**KEIZER PLANNING DEPARTMENT
NOTICE OF DECISION
Partition Case 2024-08**

The following report reviews a land use application to divide an existing parcel totaling approximately 17,859.6 square feet into two parcels comprised of approximately 5,348 square feet net (Parcel 1) and approximately 9,282 square feet (Parcel 2). Currently, the property is developed with a single-family dwelling. (Exhibit 1)

EXHIBIT 1

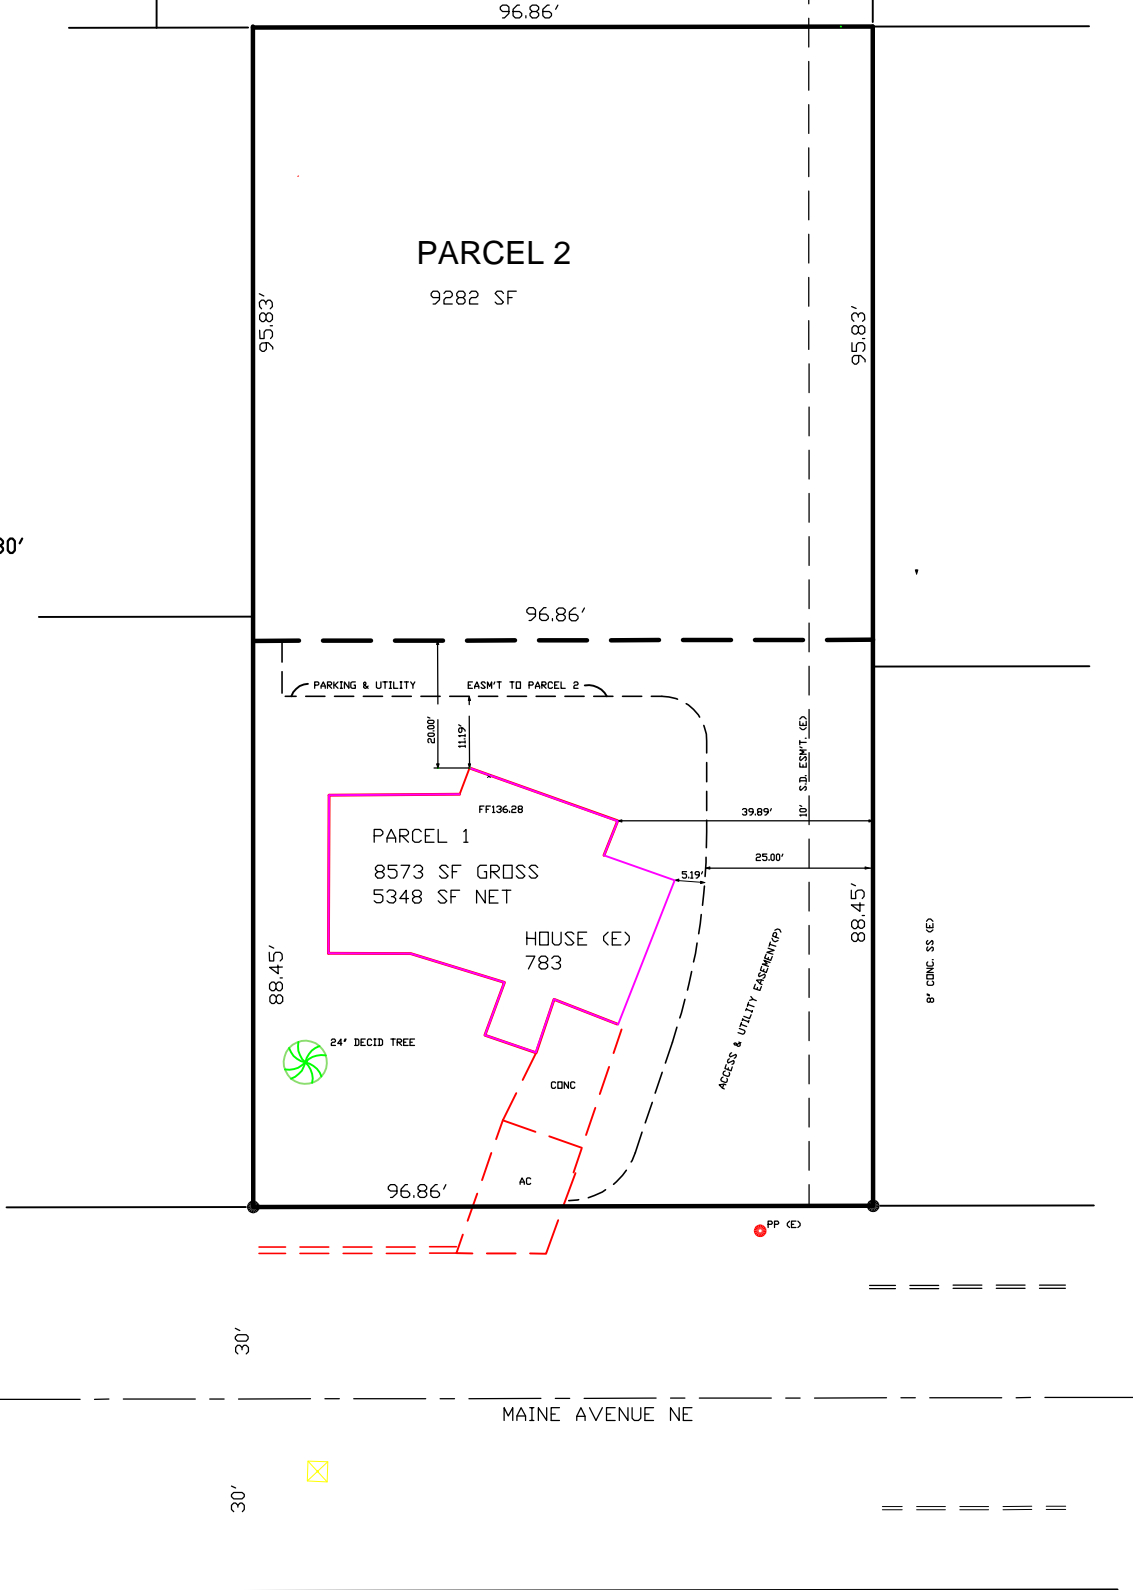
The existing home has frontage along Maine Avenue of approximately 96.8' which exceeds the minimum lot average width requirement of 40'. The applicant is proposing to remove the existing driveway on Maine Av NE allowing both lots to obtain vehicular access from the proposed new access easement. Both parcels will exceed the minimum requirement of 20' of frontage along the access easement. Keizer Public Works Department submitted comments requiring the existing driveway be closed and will be placed as a condition of approval and will be confirmed through the process of platting the partition. Staff finds this proposal can comply with this criterion.

The RS zone also regulates setback requirements in the dimensional standards section of the development code. The minimum rear-yard setback required for a one-story home is 14'. The existing one-story home on Parcel 1 will need to demonstrate the minimum rear-yard setbacks will be met with the new created Parcel 2. A site plan, prepared by a licensed engineer or surveyor and submitted to the City of Keizer Planning Department demonstrating the existing dwelling on Parcel 1 meets the minimum rear setback requirement of the RS zone for a one-story dwelling will be placed as a condition of approval. With this condition, staff finds this request can satisfy this criterion.

The applicant's proposed site plan shows Parcel 1 as approximately 5,348 square feet in net area with an existing single-family dwelling. The applicant's site plan indicates the existing house on Parcel 1 will be retained as allowed on lots over 4,000 square feet in size. Parcel 2 is approximately 9,282 square feet in size. Parcels over 7,000 square feet can be developed with single-family detached dwellings, duplex, triplexes, quadplexes or cottage clusters. The applicant's written statement indicates the desire to build a quadplex.

FINDINGS: The applicant's site plan indicates both lots will obtain vehicular access from the proposed private access easement and exceed the minimum frontage requirement of 20' on the easement. Therefore, staff finds this request satisfies this criterion.

FINDINGS: The applicant is proposing an access easement of 20' to serve both lots. The Keizer Development Code requires a width of 20' if serving a single family or duplex development. Triplex, quadplex, cottage cluster or multi-family development requires a width of 22' for the access easement along with Keizer Fire District approval for Fire Code regulations. The applicant has stated their desire to build a quadplex which would require a 22' access easement fully paved. The proposed plan submitted could accommodate the wider access easement. The standards governing access

Turn-around: The KDC and the Keizer Fire District require a turn-around for access easements serving two or more dwelling units. The access easement is proposed to serve both lots, therefore a turn-around is required. The applicant has submitted a site plan (Exhibit 1) that does not show a turn-around, however Staff believes a turn-around can be designed to comply with this requirement. The plat must show the turn-around and will be reviewed by the City Engineer to ensure dimensions and turning radius requirements are met.

3. **Dead end roads:** Dead end fire apparatus access roads in excess of 150 feet in length shall be provided with an approved turnaround. We can provide you with approved turn around per our Marion County Fire Code Applications Guide & 2022 Oregon Fire Code 503.2.5. **Proposed turnaround does not meet requirements.**

3. The existing house must be modified so a minimum 5' setback to the newly created access easement can be achieved.
4. The applicant shall submit a final partitioning plat prepared by a registered professional surveyor which conforms to the approved preliminary plat. Following plat approval, the final plat and title transfer instruments accomplishing the property adjustments shall be recorded with the Marion County Clerk by June 27, 2026. The plat shall include all engineering elements as required by the Department of Public Works.

7. A site plan, prepared by a licensed engineer or surveyor must be submitted to the City of Keizer Planning Department demonstrating the existing dwelling on Parcel 1 meets the minimum rear setback requirement of the RS zone.

8. Unless waived in writing by the adjacent property owners, a 6’ sight-obscuring fence, wall, or hedge is required along the east side of the access easement to provide screening to the adjacent properties. If waived, documentation must be submitted to the City of Keizer Planning Department.
